REVISIONS 7-28-20 REVISED PER COUNTY REVIEW COMMENTS DEW

PROJECT
10634 & 10658 MALTESE POINT
LOTS 2 & 3, ROLLING THUNDER BUSINESS PARK
EL PASO COUNTY

SHT. NAME
GRADING AND EROSION CONTROL PLAN

SHT. NO.
1 OF 2

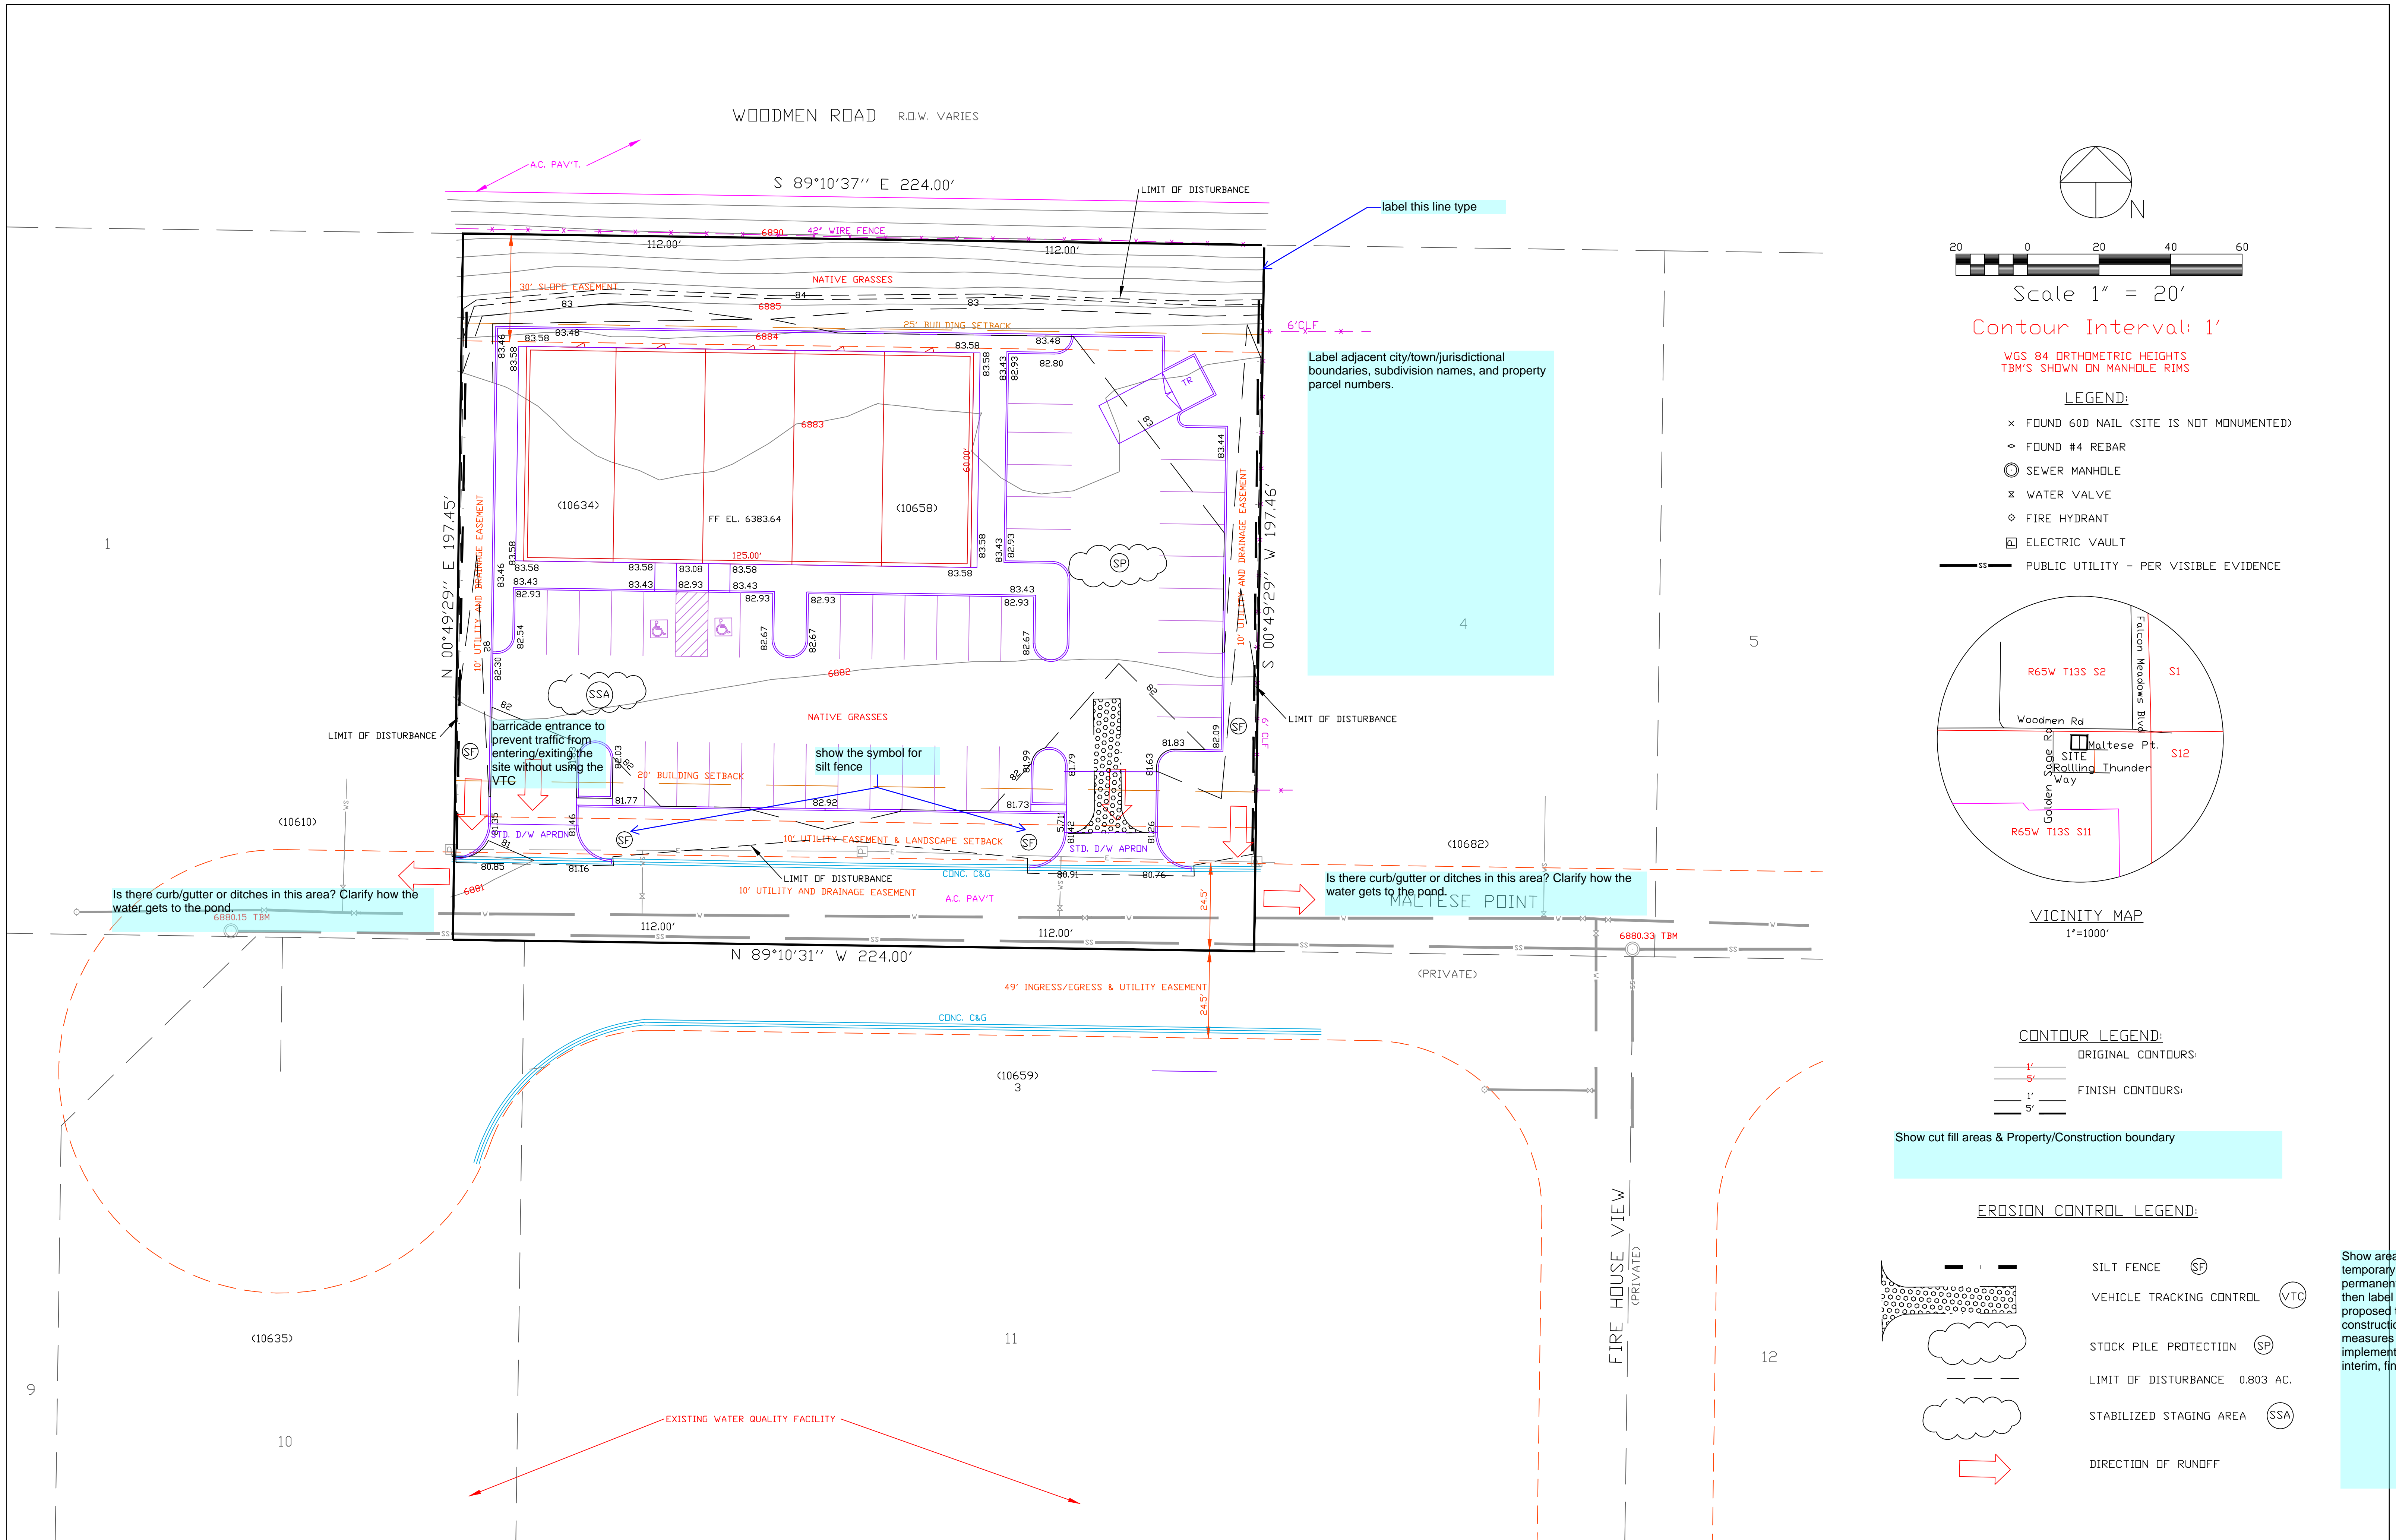
Show cut fill areas & Property/Construction boundary

Show areas of temporary and permanent seeding then label all proposed temporary construction control measures by phase of implementation (initial, interim, final)

label this line type

Label adjacent city/town/jurisdictional boundaries, subdivision names, and property parcel numbers.

show the symbol for silt fence

Is there curb/gutter or ditches in this area? Clarify how the water gets to the pond.

Is there curb/gutter or ditches in this area? Clarify how the water gets to the pond.
